GE HEADQUARTERS PROJECT

BCDC DESIGN SUB-COMMITTEE REVIEW

September 13th, 2016

FUTURE PARK CONNECTION

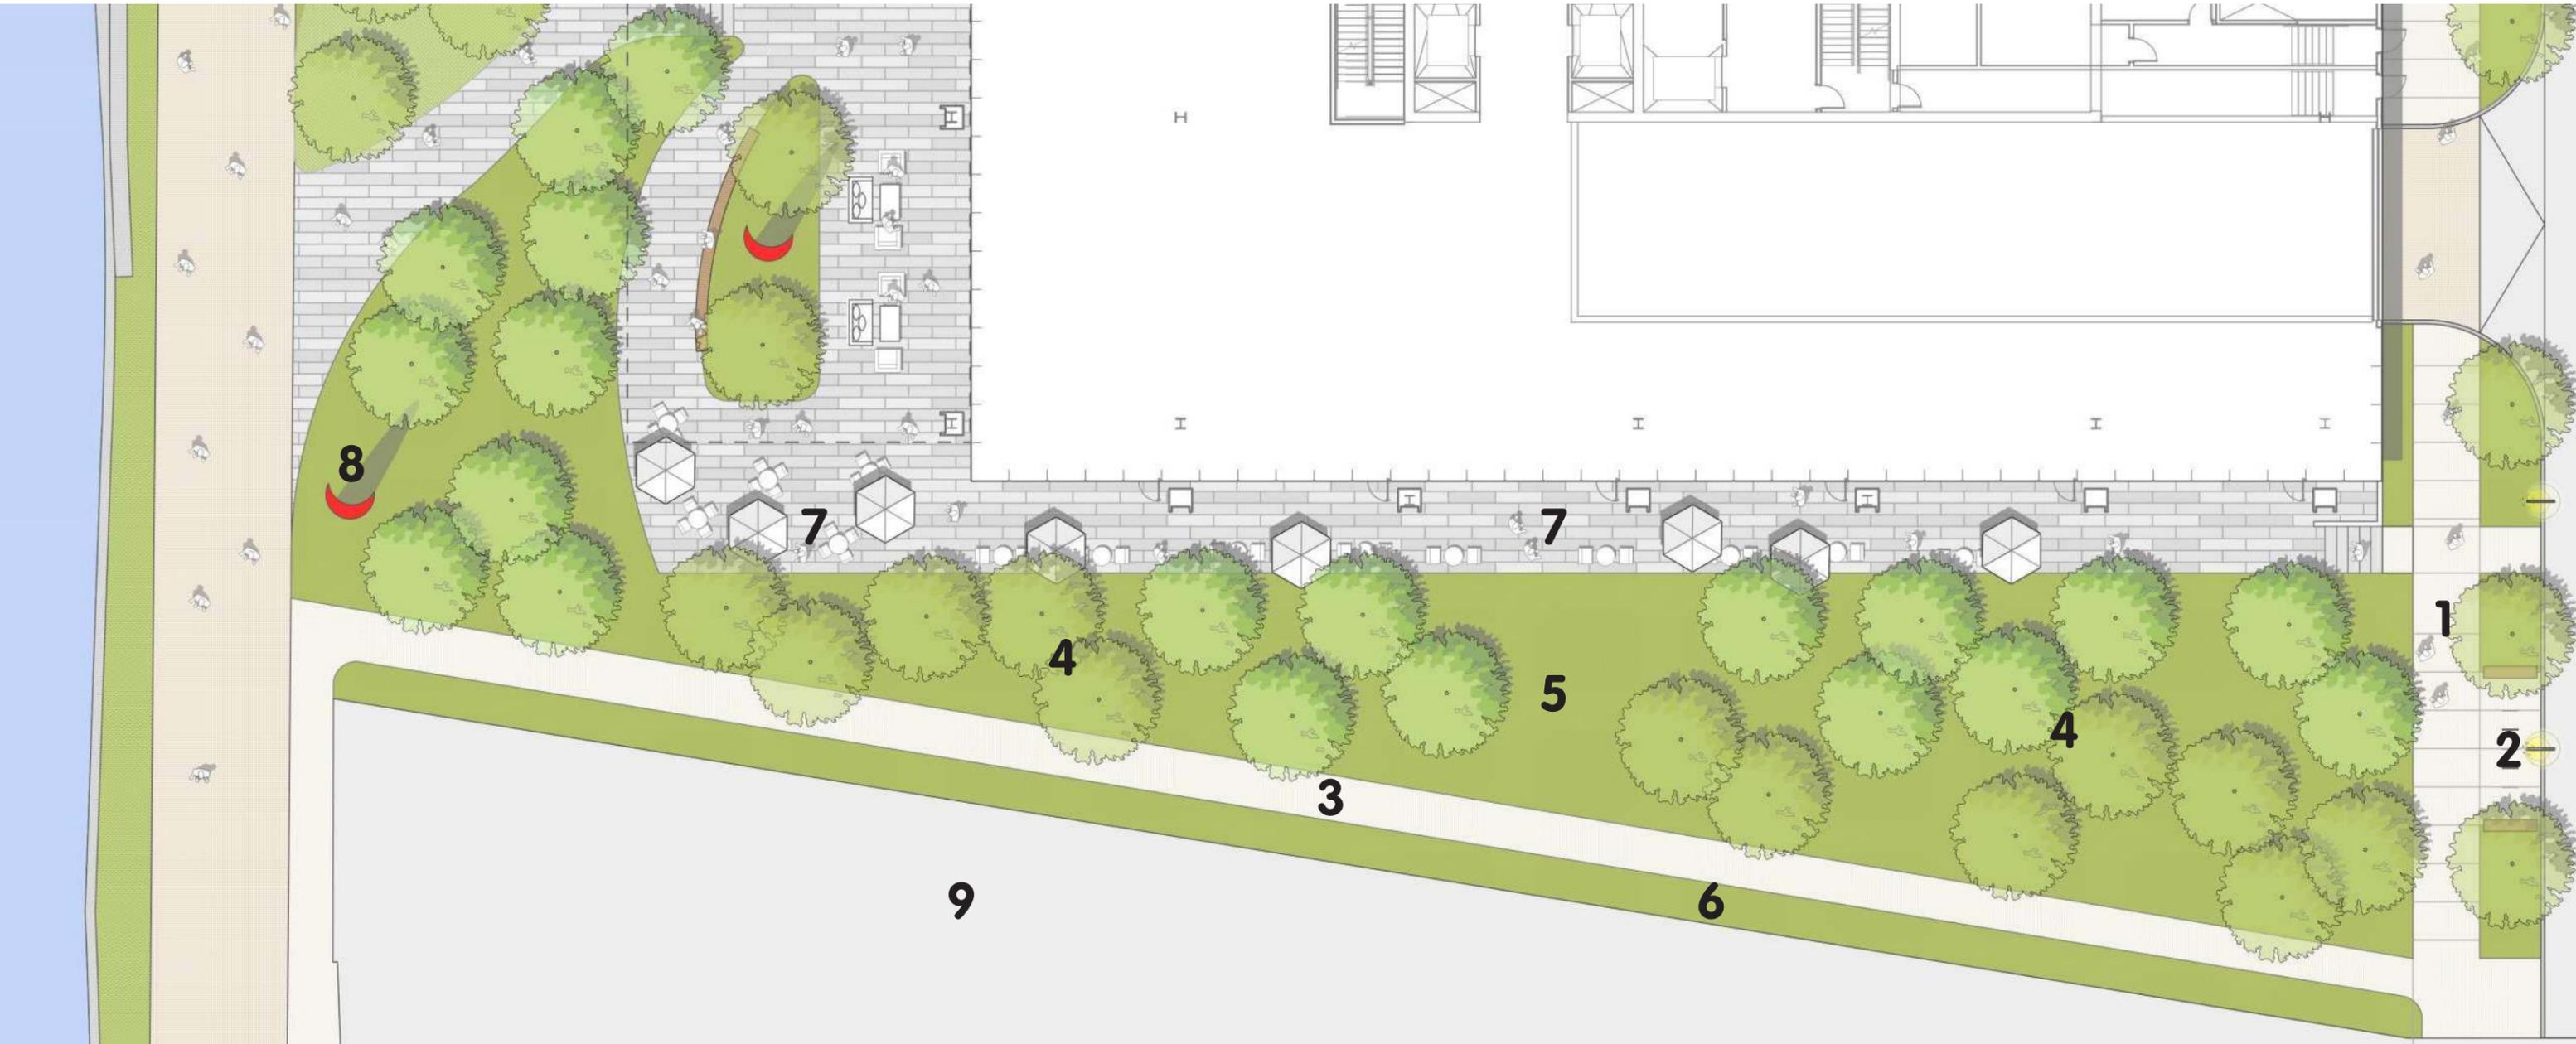
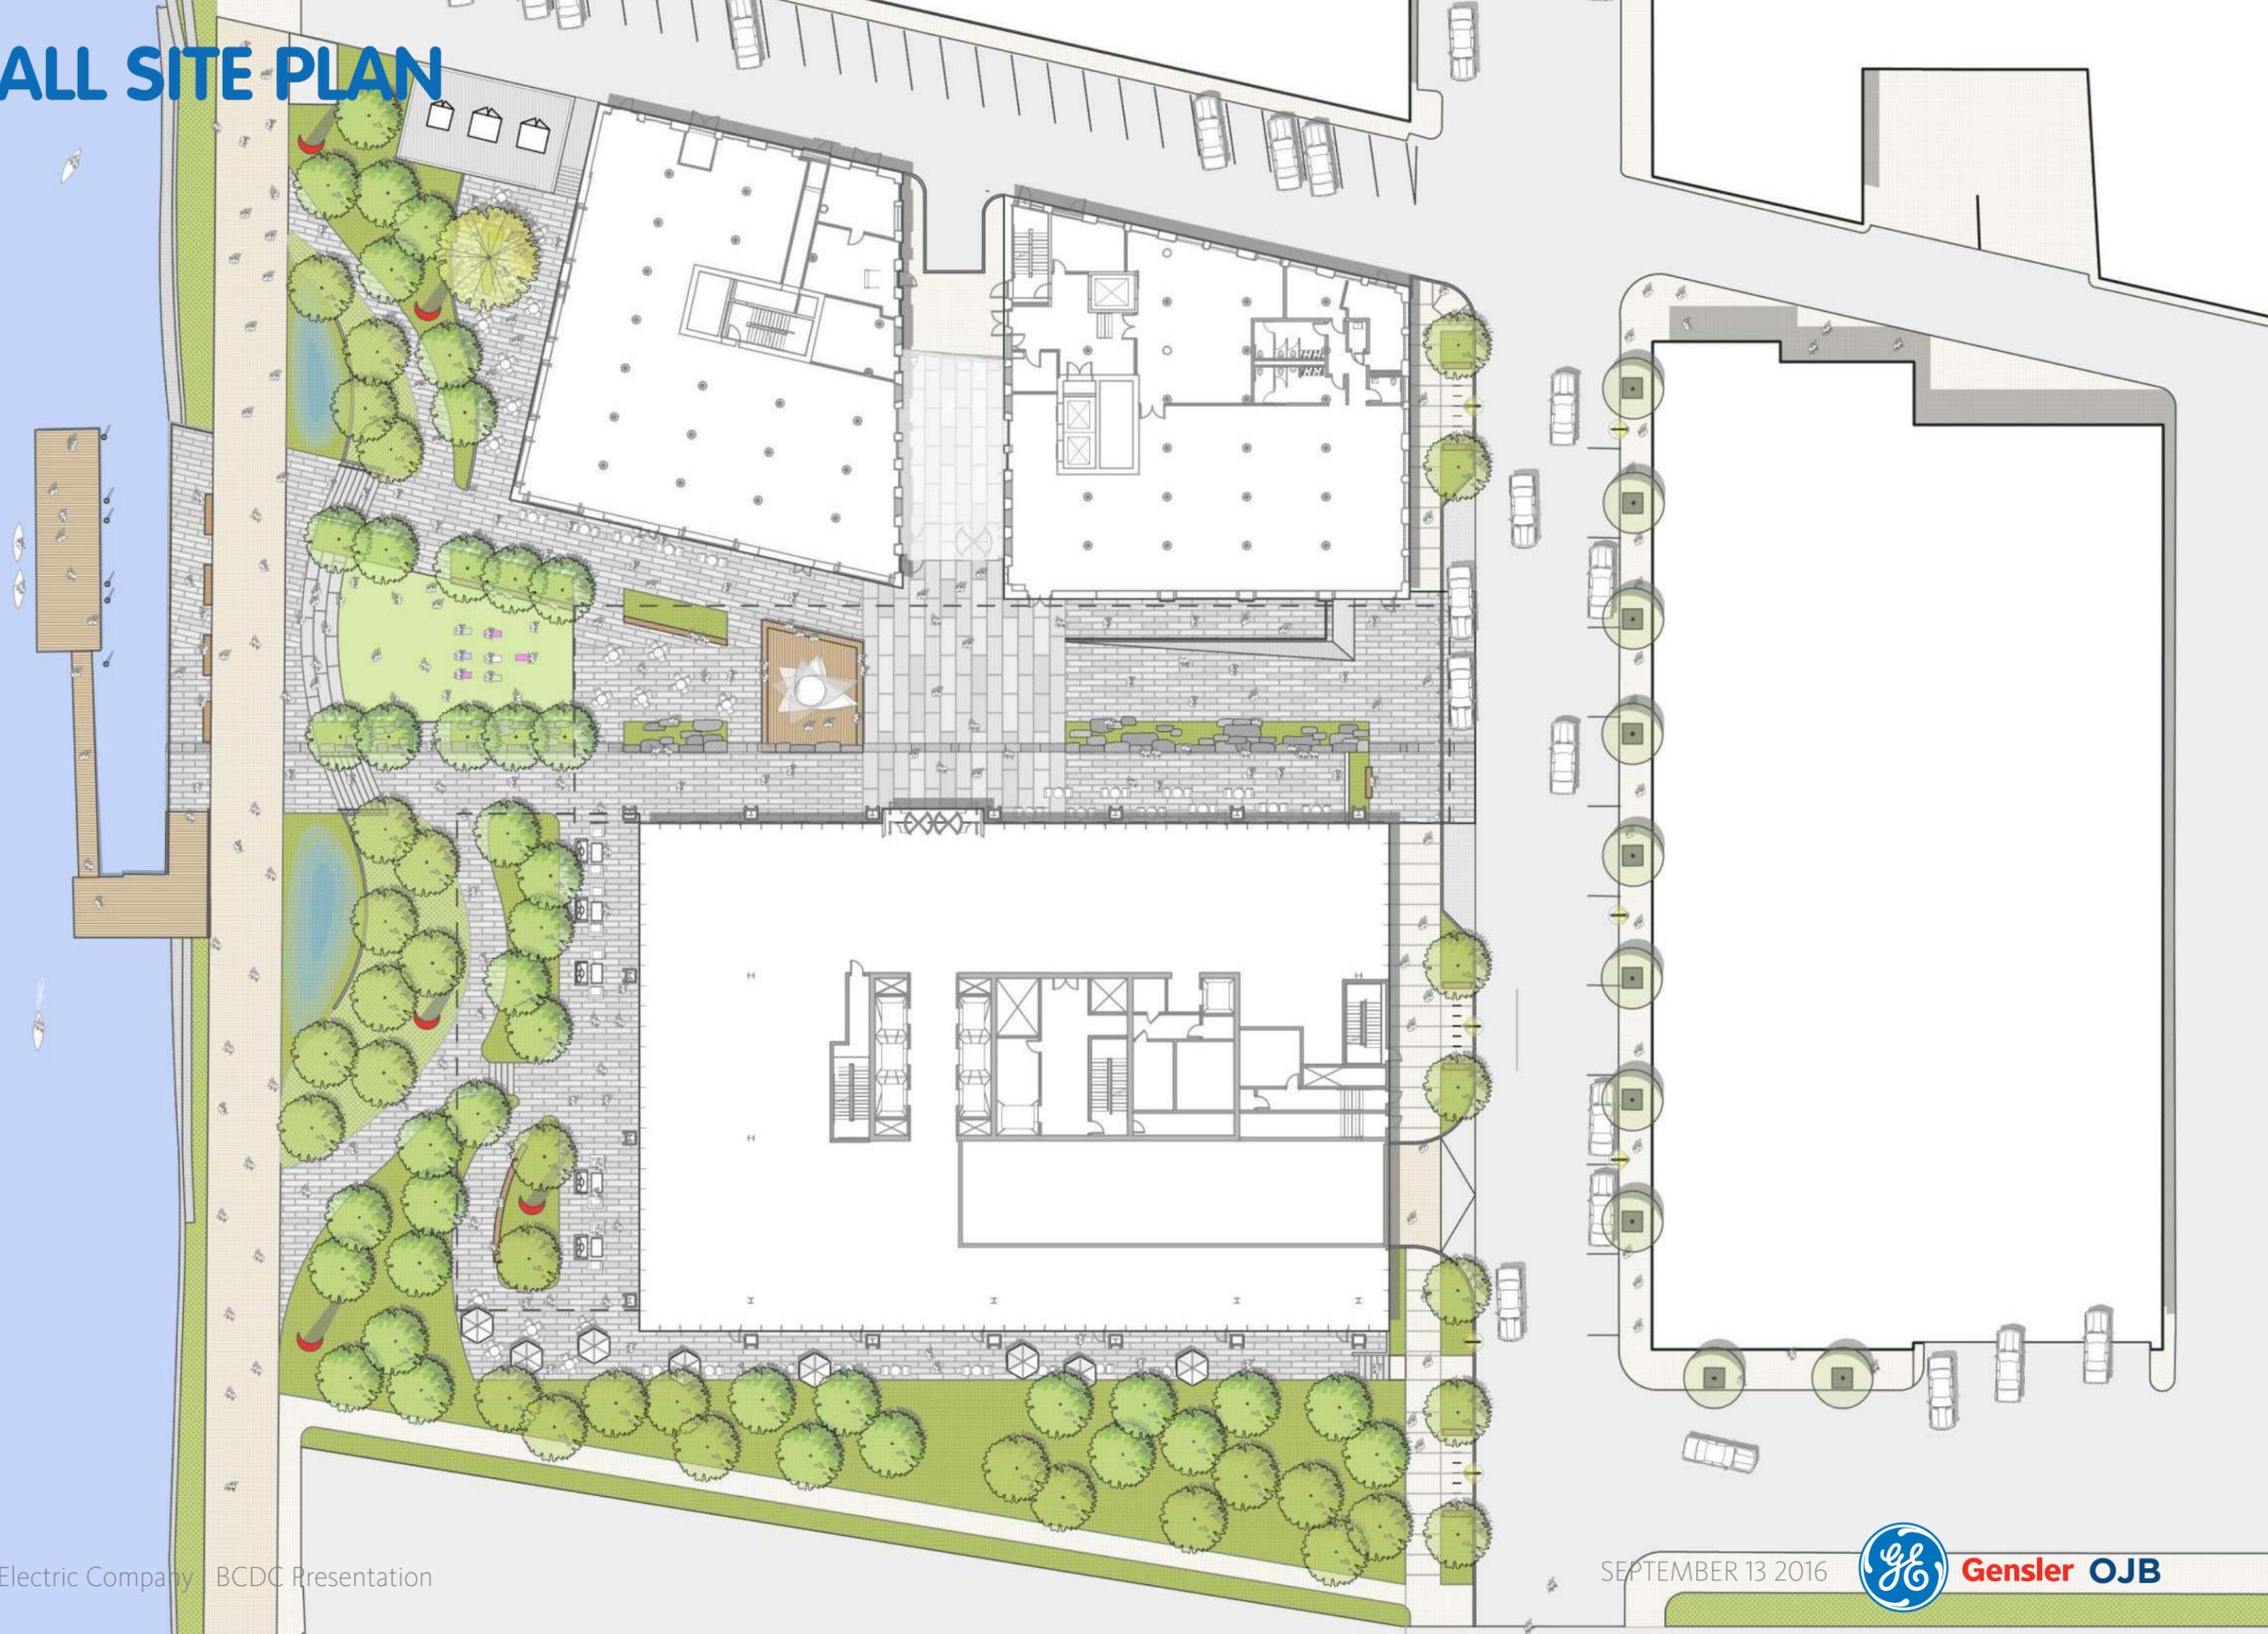
- 1 NEEDS MORE ATTENTION - FEELS LIKE AN AFTER THOUGHT
- 2 PLANNED FOR AN ACTIVE EDGE IN 100-ACRE PLAN
- 3 CONSIDER INFORMING FUTURE DEVELOPMENT (CHANNEL PARK)

- 1** NECCO STREETScape
- 2** BIKE RACKS + SEATING
- 3** HARBORWALK CONNECTOR
- 4** WIND MITIGATING PLANTINGS
- 5** TRANSITIONAL LANDSCAPE
- 6** PARKING LOT BUFFER
- 7** MUSEUM PROGRAM EXTENSION
- 8** PUBLIC ART INFRASTRUCTURE
- 9** EXISTING PARKING / FUTURE PARK
